ADDENDUM NO. 3

February 6, 2023

**SOLON ROBINSON ELEMENTARY SCHOOL ADDITIONS,
RENOVATIONS, AND RELATED WORK
Crown Point, IN 46307**

© GIBRALTAR DESIGN	SHEET
A	C-1.2A

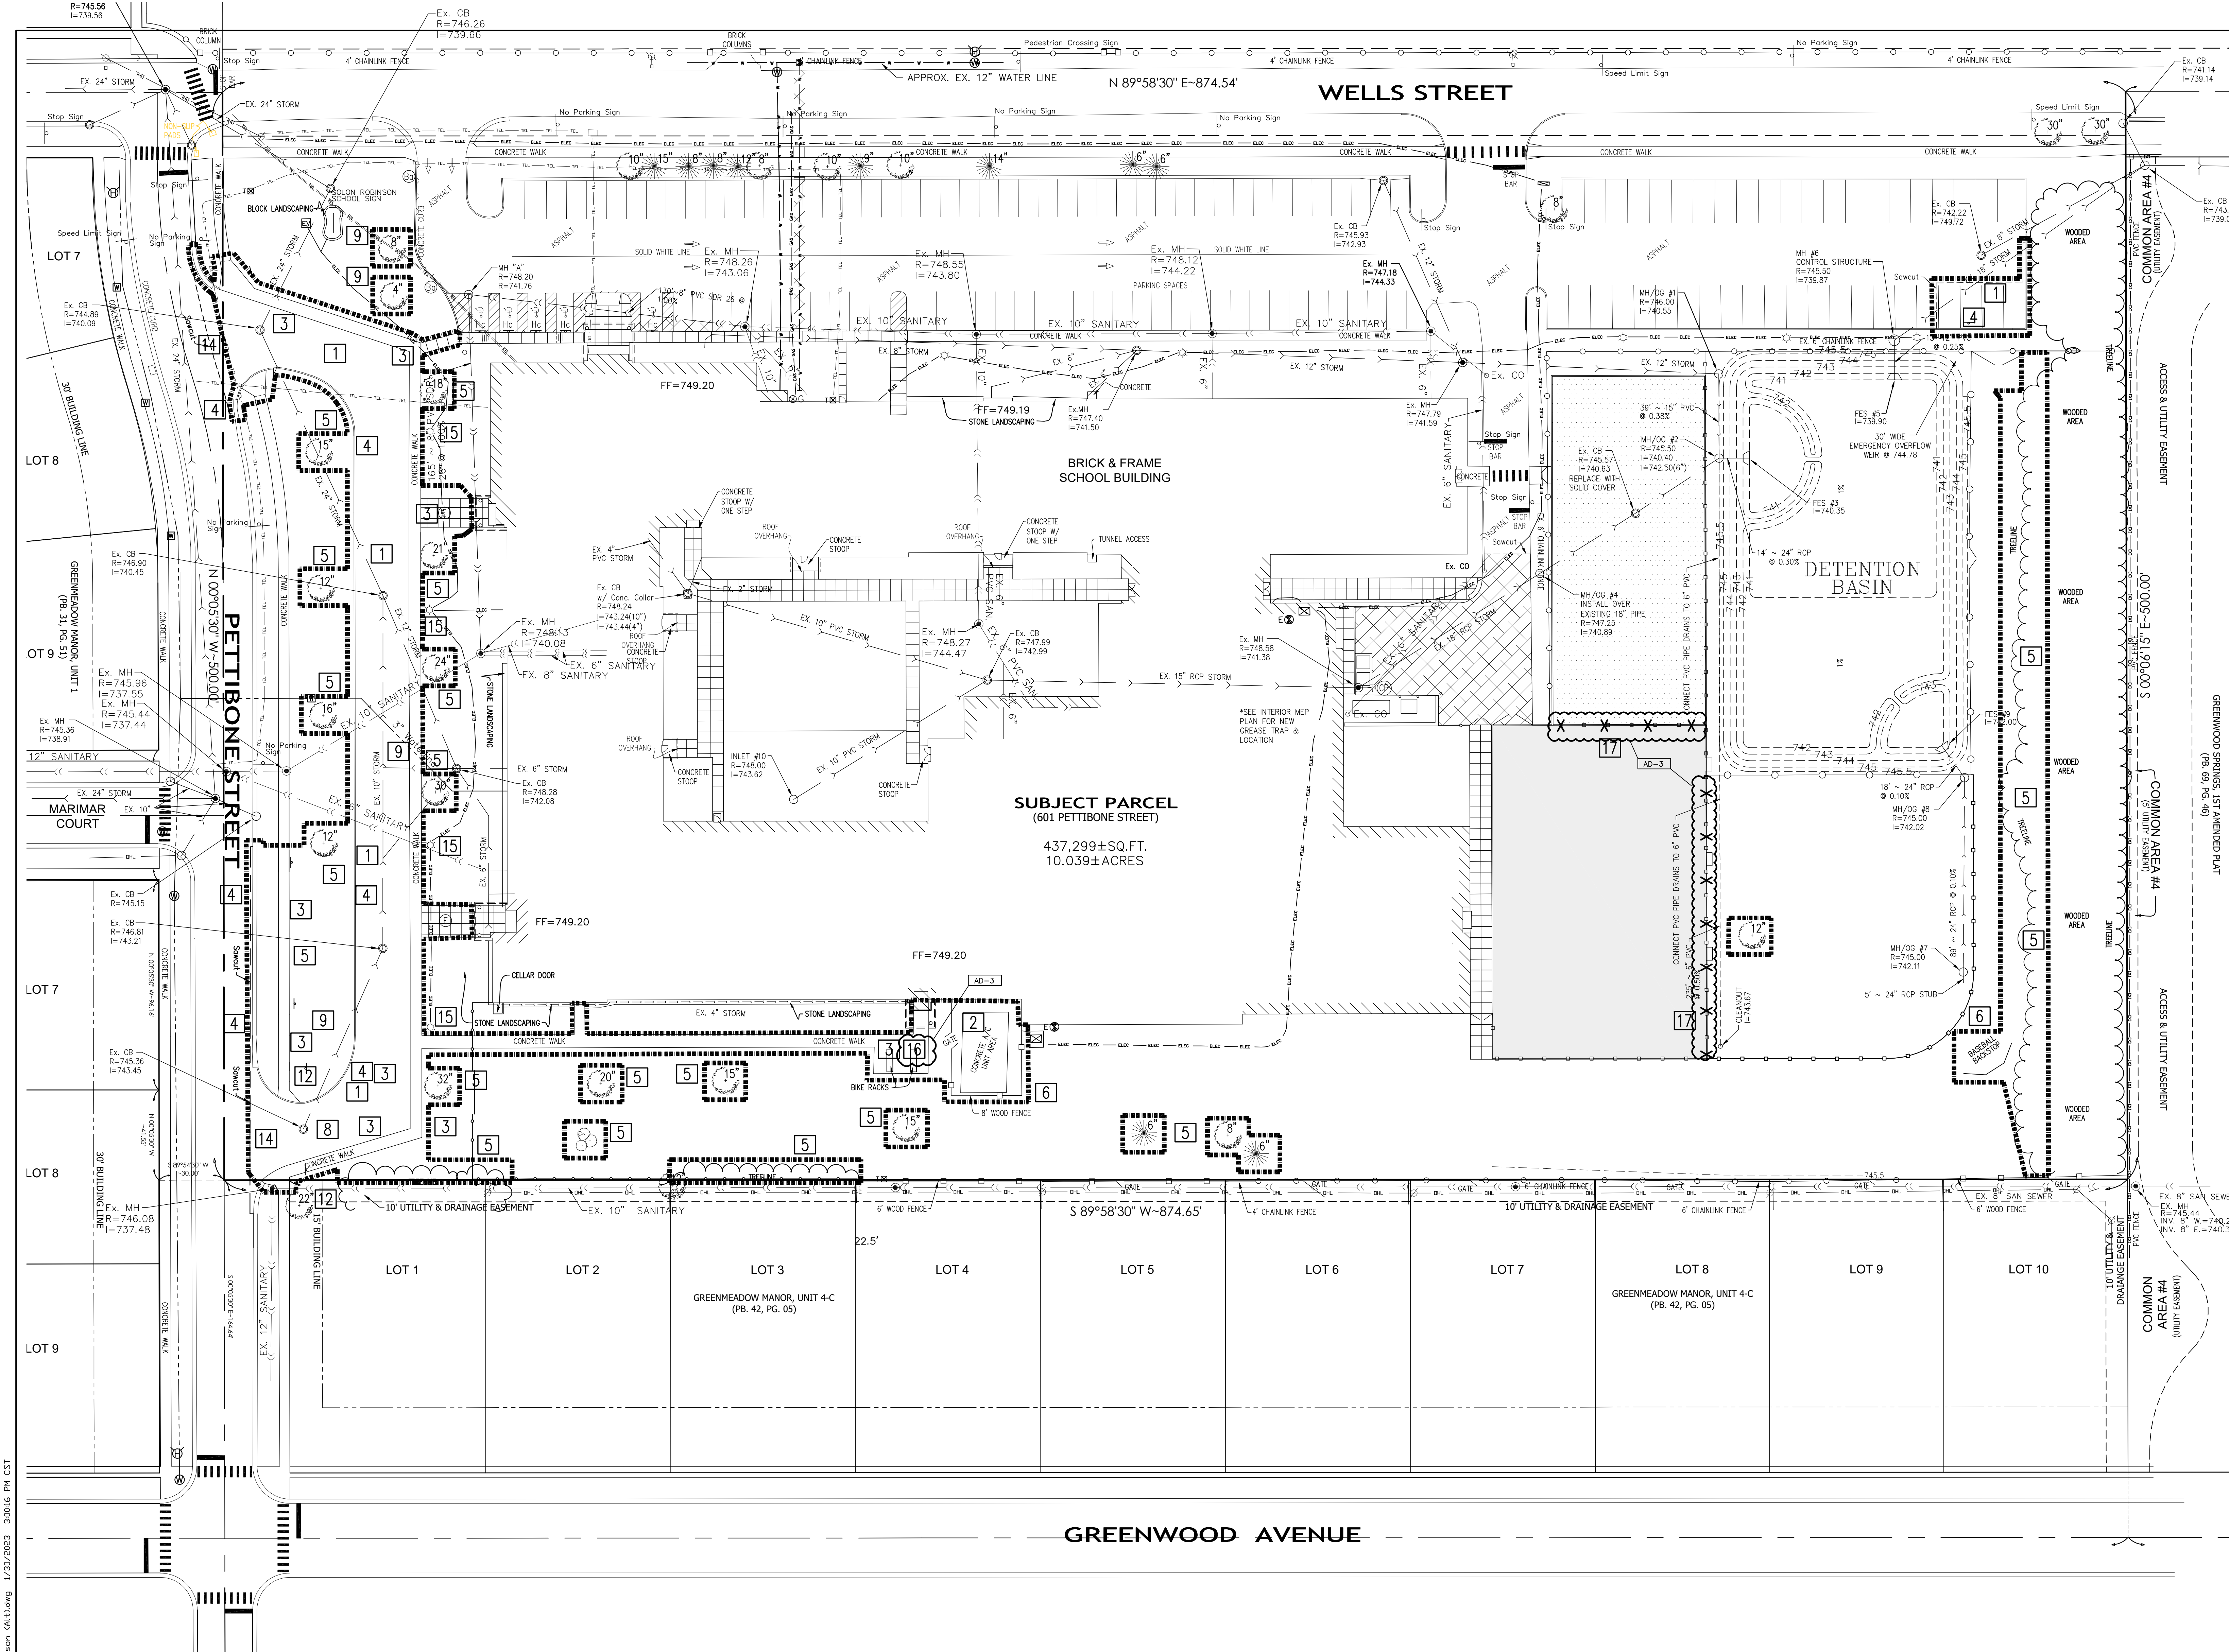
- A. Remove and reinstall bike racks at the south side of the existing building.
- B. Remove and relocate north portion of the fence and a portion of the east fence of the base hard play area.
